Portishead Branch Line - MetroWest Phase 1

Statement with regard to Trinity Footbridge

Portishead Branch Line - MetroWest Phase 1 project

Trinity Footbridge

7. Catchment area (Village Quarter)

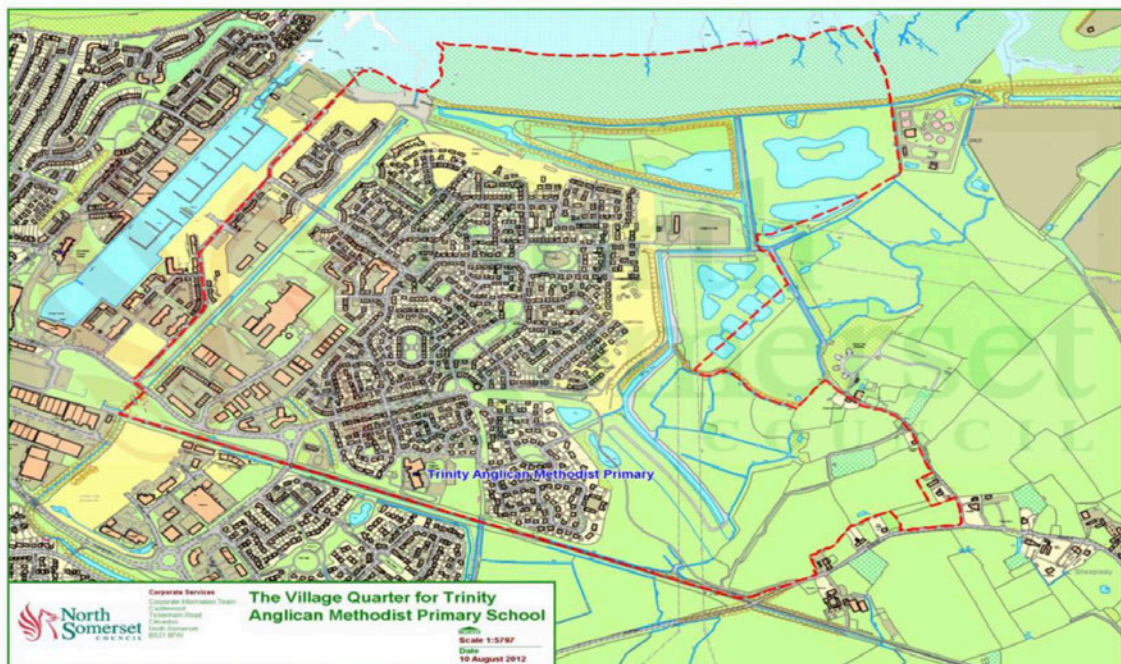
This proposed bridge is not necessary to enable students to reach Trinity school as the school catchment area falls entirely to the north of the proposed railway line. See attached map.

7. Catchment area (Village Quarter)

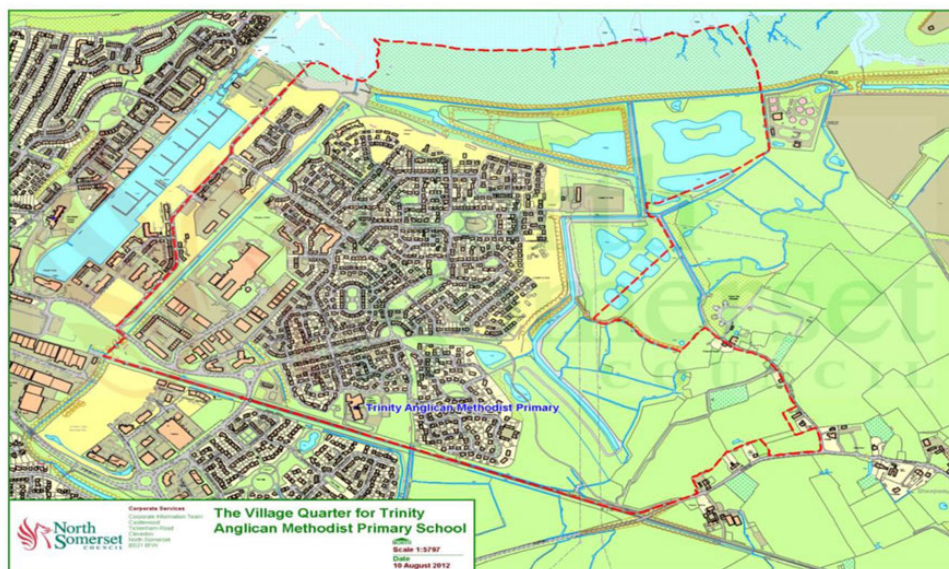
The secondary reason for the bridge being unnecessary is the justification used for its existence is flawed. Trinity school catchment is entirely the other side of the railway line (See map below) and therefore the school users should be minimal. Those already using the pre-existing cut through already have another route via the roadway which would be enhanced by the proposed level and lit gravel paths as part of the station construction.

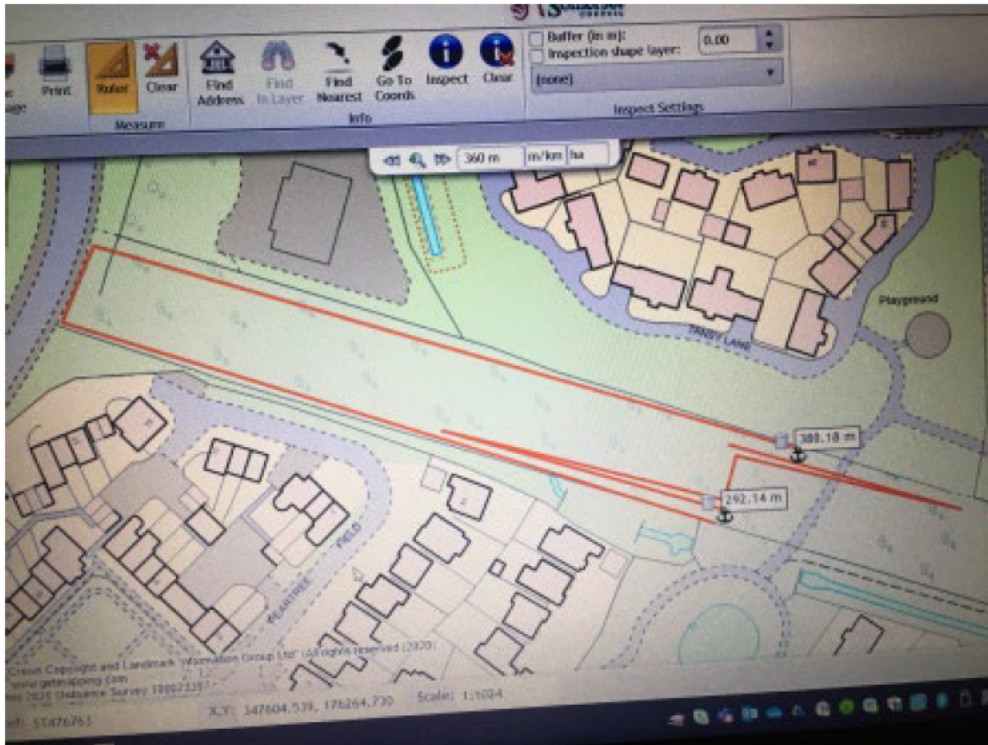
With regard to our statement that the route using the proposed footbridge is barely shorter than using the alternative footpath route around the station we have now been able to have this distance measured.

To cross the railway using the Footbridge ramps is approx 290m. To walk around the station using the proposed footpaths is approx 380m. This means users would need to walk about an extra 100m which would take just over a minute extra per journey. Please see attached diagram.
